**RE: Lot 12 Block 9 Unit 18 Volcano Cliffs SAD 228
6520 Papagayo NW
Grading and Drainage Plan
Engineers Stamp Date 4/21/17 (D10D003112)
Pad Certification Date 4/21/17**

Based upon the information provided in your submittal received 5/24/17, this plan is approved for Building Permit.

ENGINEER'S SEAL 4/21/17 DAVID SOULE P.E. #14522	LOT 12 BLOCK 9 VOLCANO CLIFFS UNIT 18	DRAWN BY JDG
	GRADING AND DRAINAGE PLAN	DATE 04-17-2017
 Rio Grande Engineering 1606 CENTRAL AVENUE SE SUITE 201 ALBUQUERQUE, NM 87106 (505) 872-0999		SHEET # 1 OF 1 JOB #

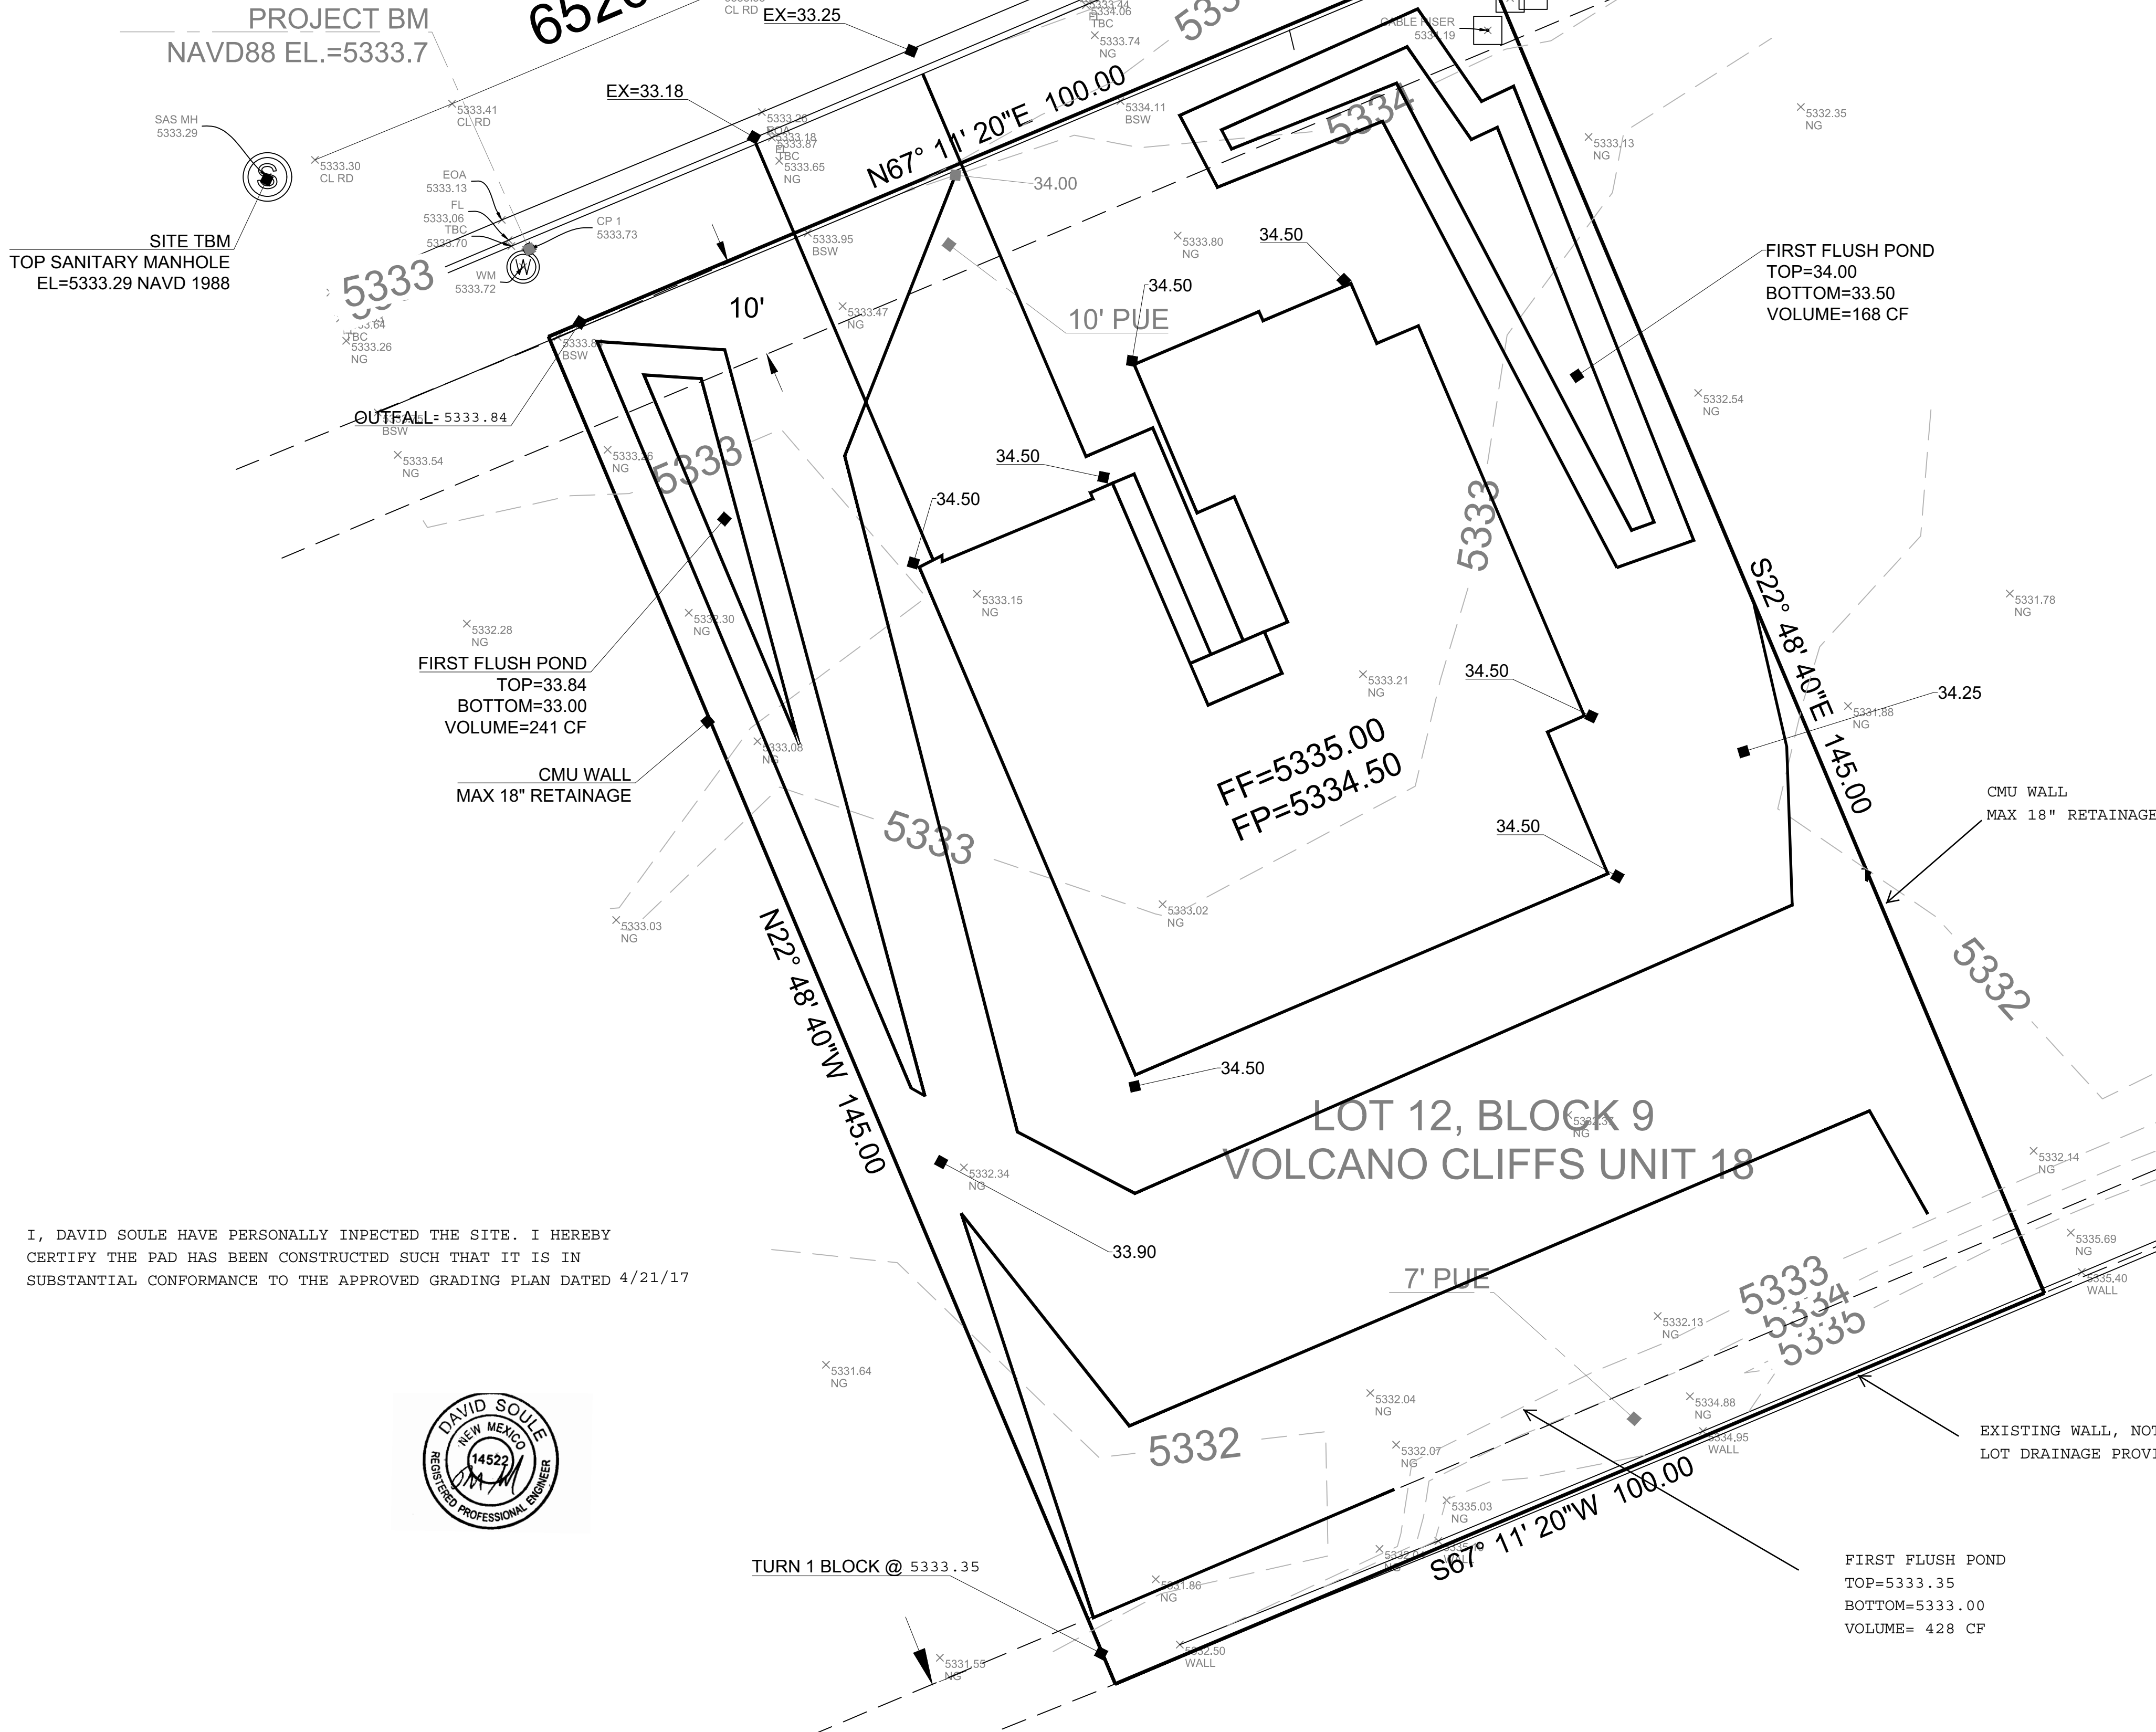
Please inform the builder/owner to attach a copy of this approved plan to the construction sets in the permitting process prior to sign-off by Hydrology. Reiterate to the Owner/Contractor that a separate permit for a garden/retaining wall must be obtained, with the approved G&D plan dated 4/21/17.

Prior to Certificate of Occupancy release, Engineer Certification per the DPM checklist of this plan will be required.
